**STAFF REPORT 04-15-2020 REGULAR MEETING**

**APPLICATION NUMBER: 20-6698**

**ADDRESS: 69 SEWARD AVENUE (THE BONITA APARTMENTS)**

**SCOPE: ERECT NEW ROOFTOP ADDITION; REHABILITATE BUILDING**

**PROPOSED WINDOWS  
QUAKER H500 SERIES  
AW-PG50**

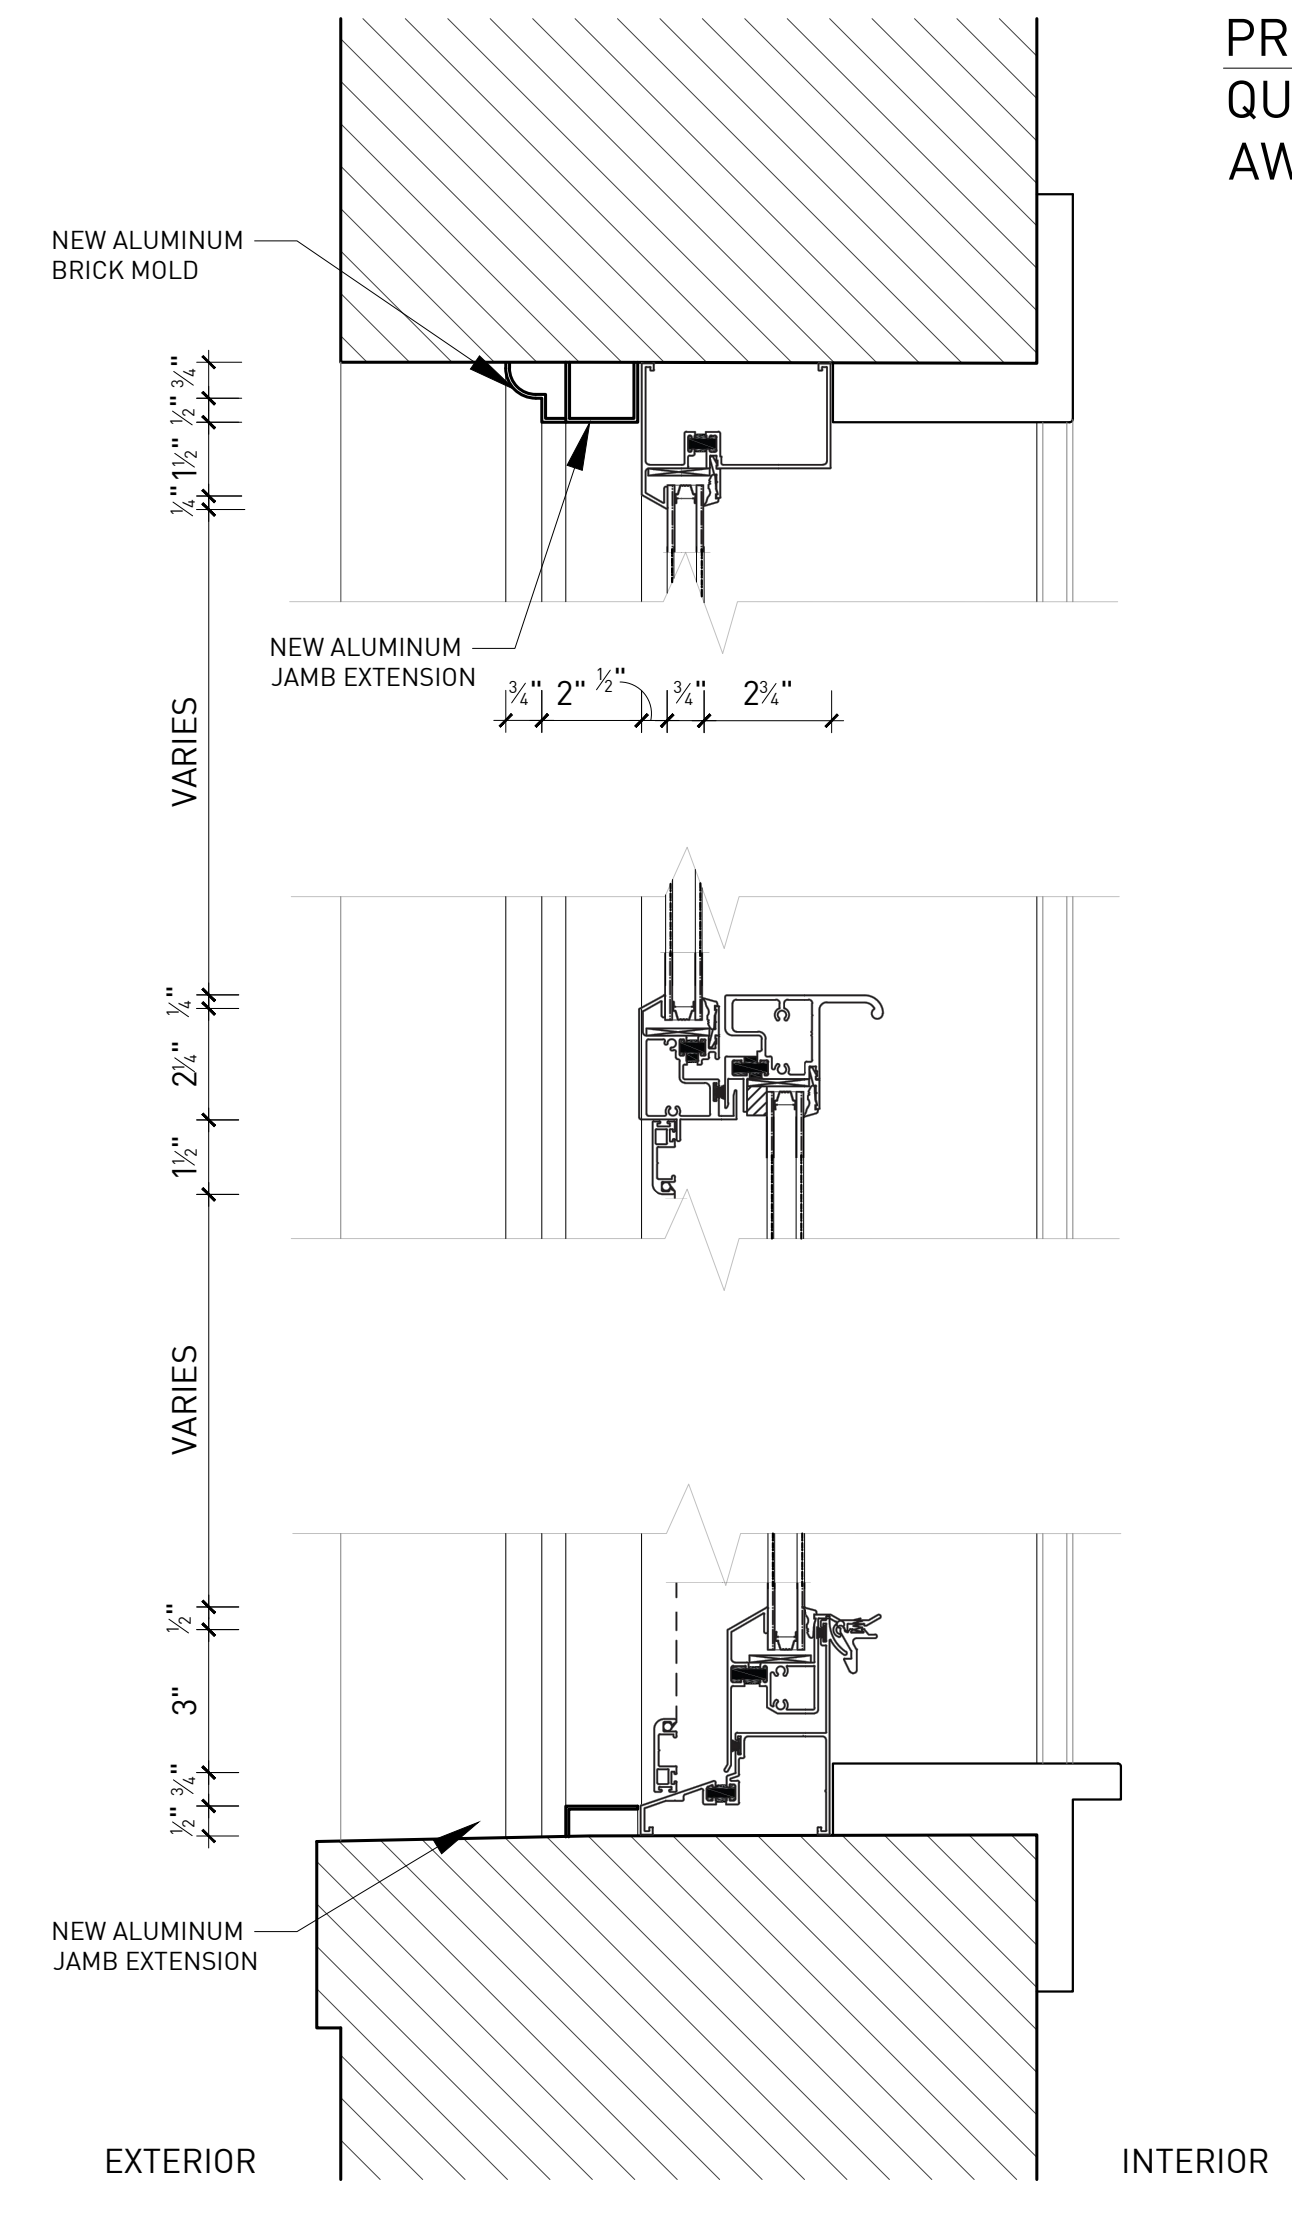
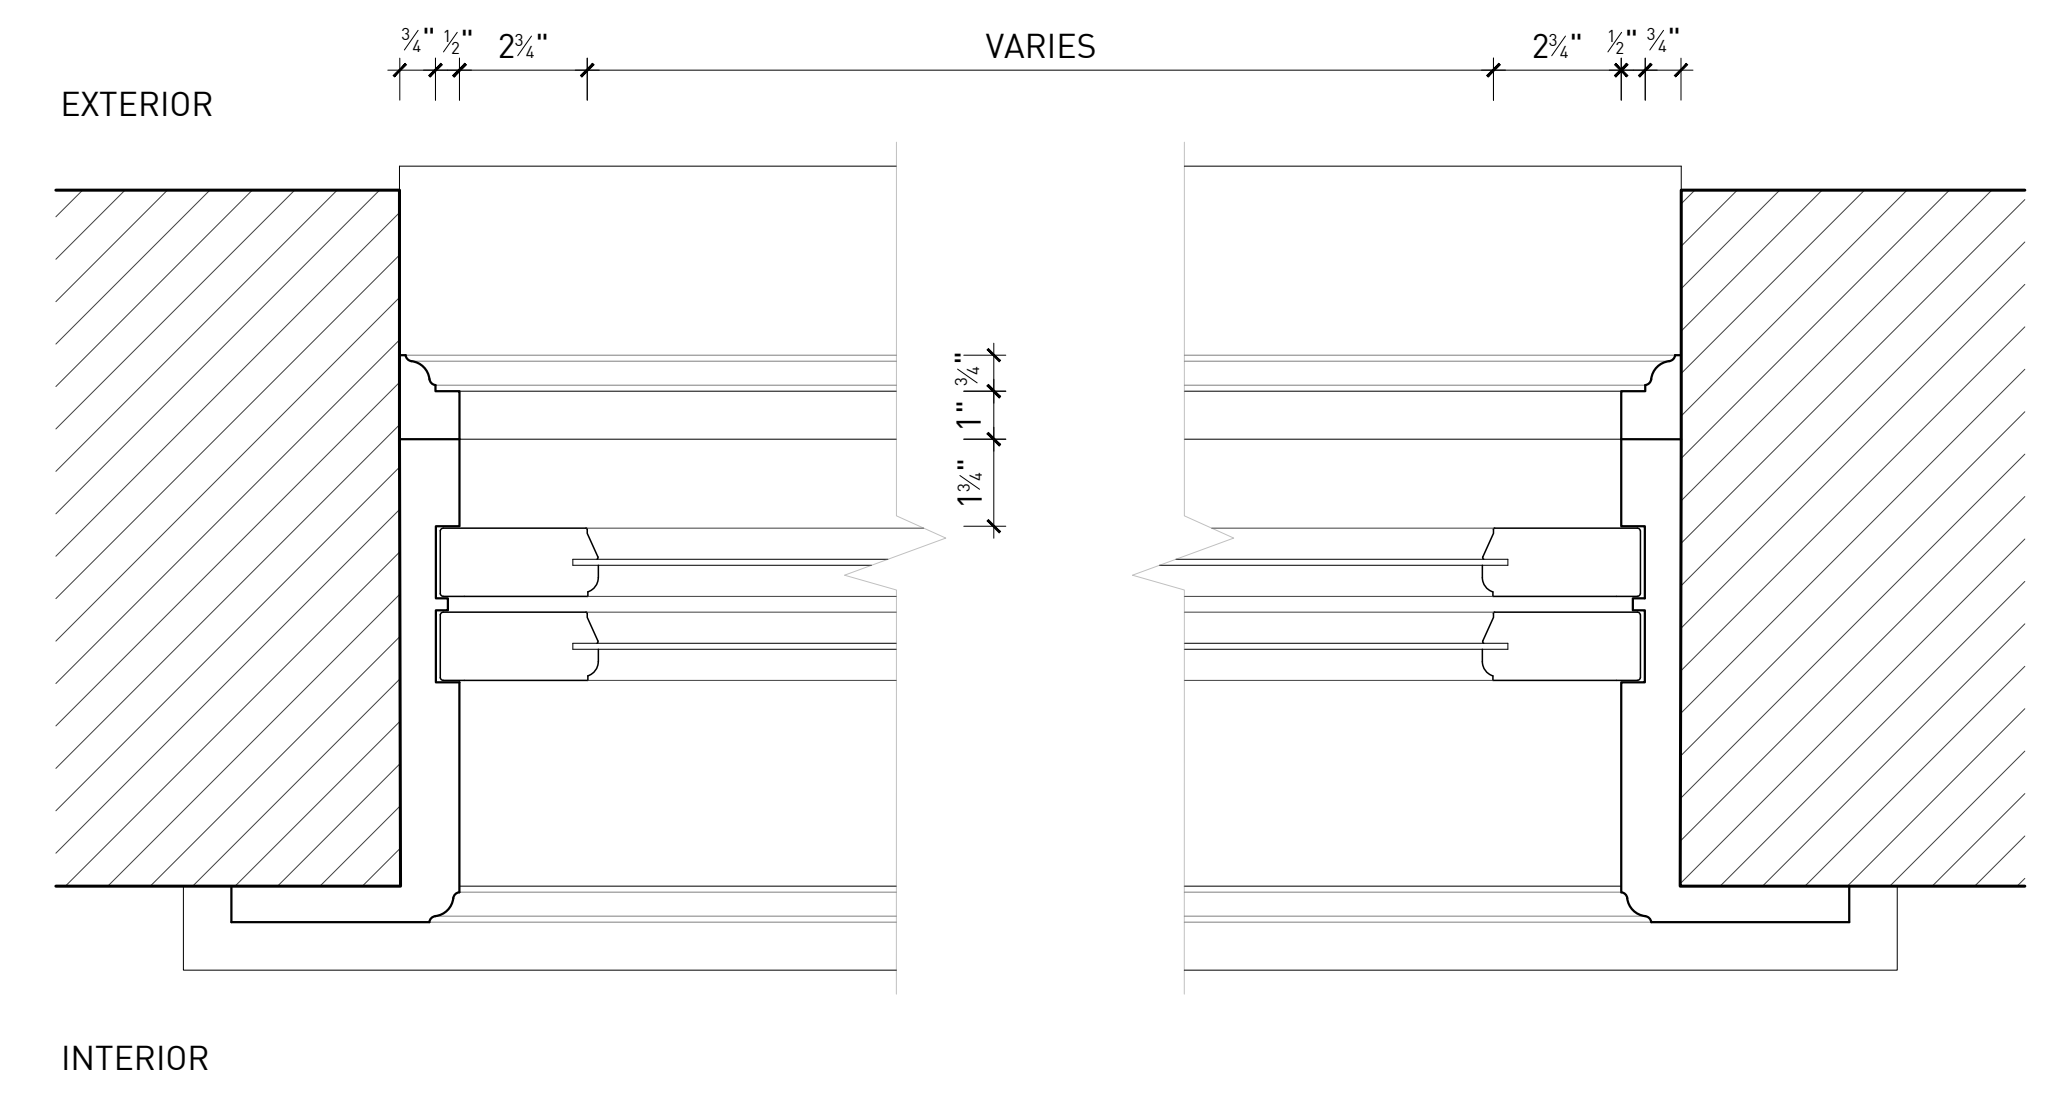
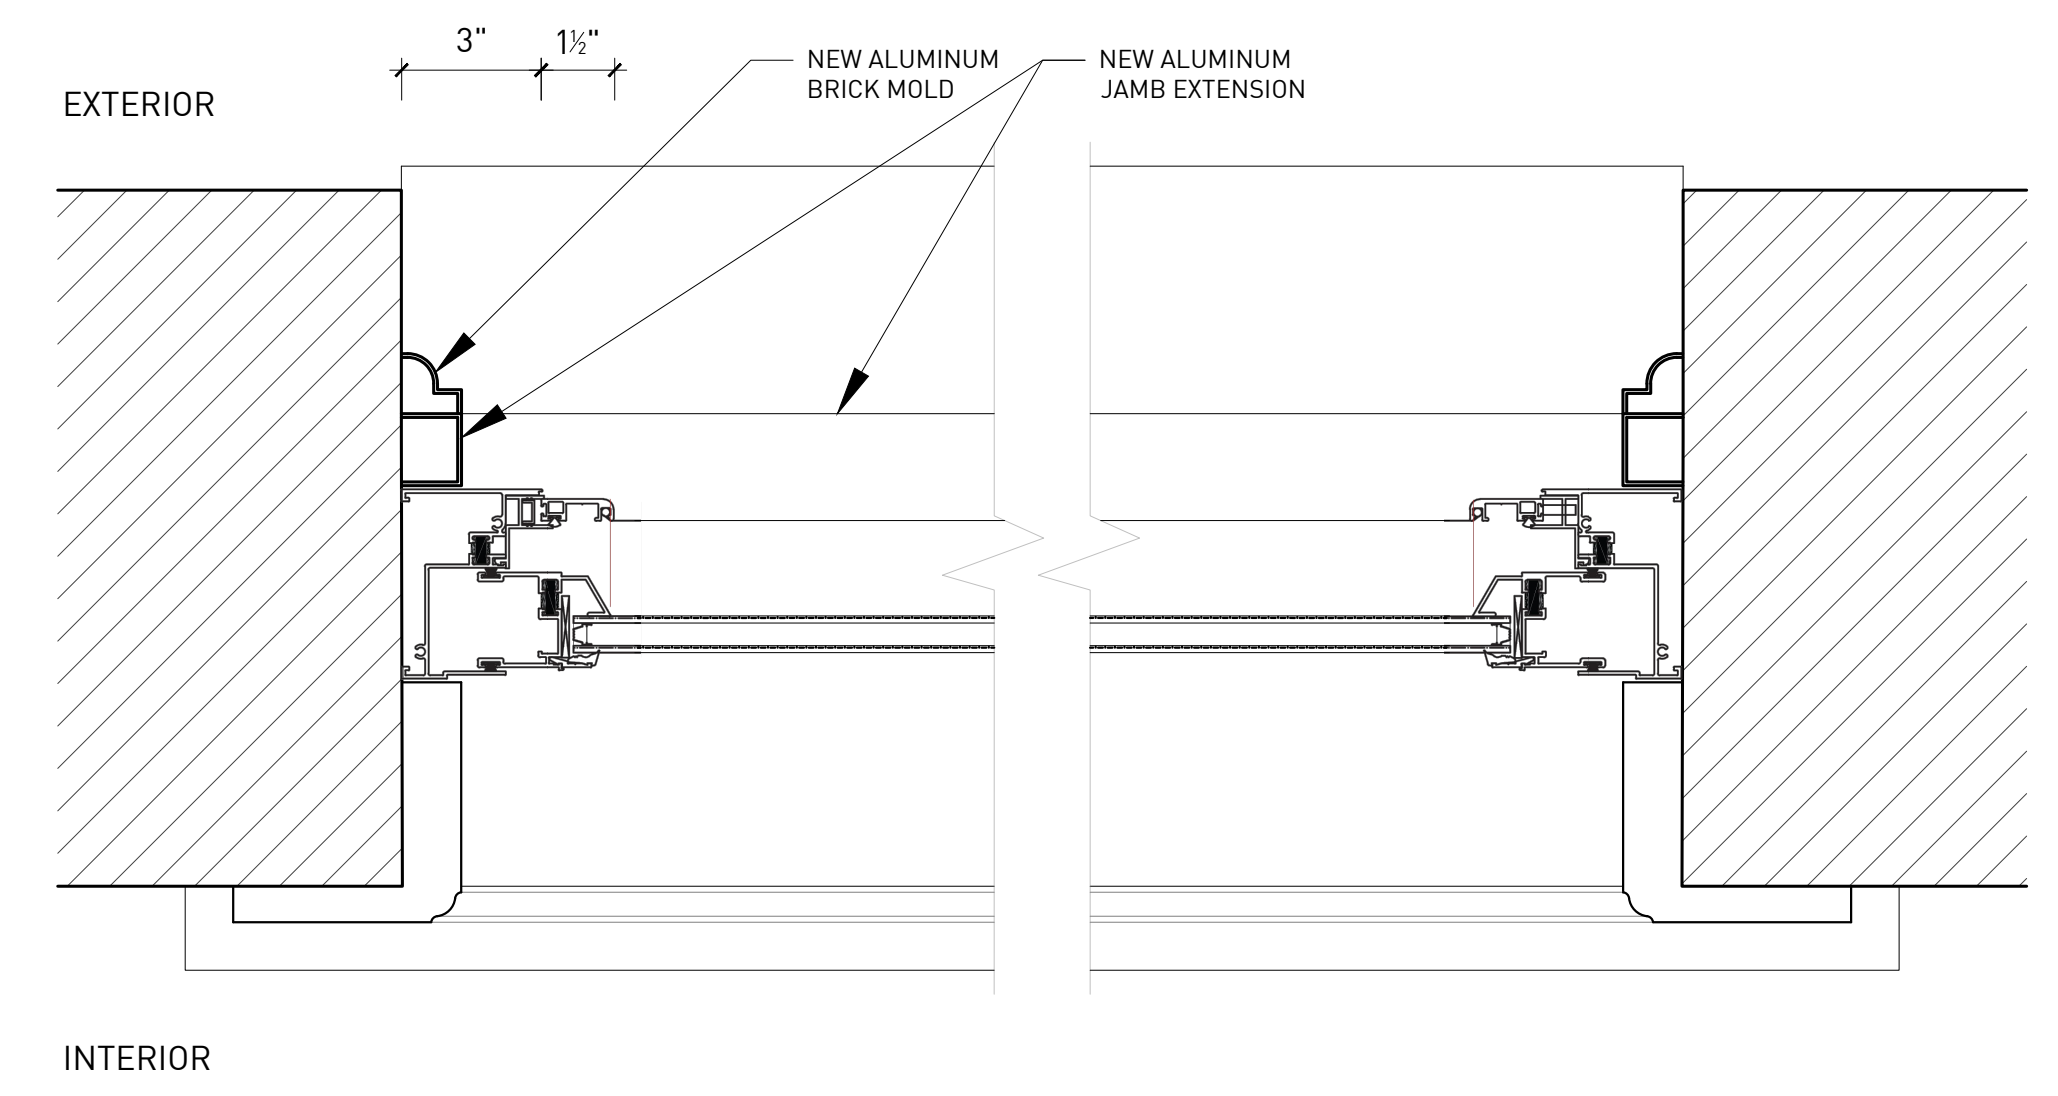
- Top Rail, Meeting Rail, Bottom Rail, and Jamb detail dimensions vary 1/2”– 1” between existing windows and proposed windows. This is a noticeable difference and will result in a substantial change to sight-lines and the appearance of the windows within the façade(s). While the majority of the existing windows appear to be beyond repair, or missing all together, the dimensions of the proposed replacement windows will impact and alter the overall character of the building, in Staff’s opinion.
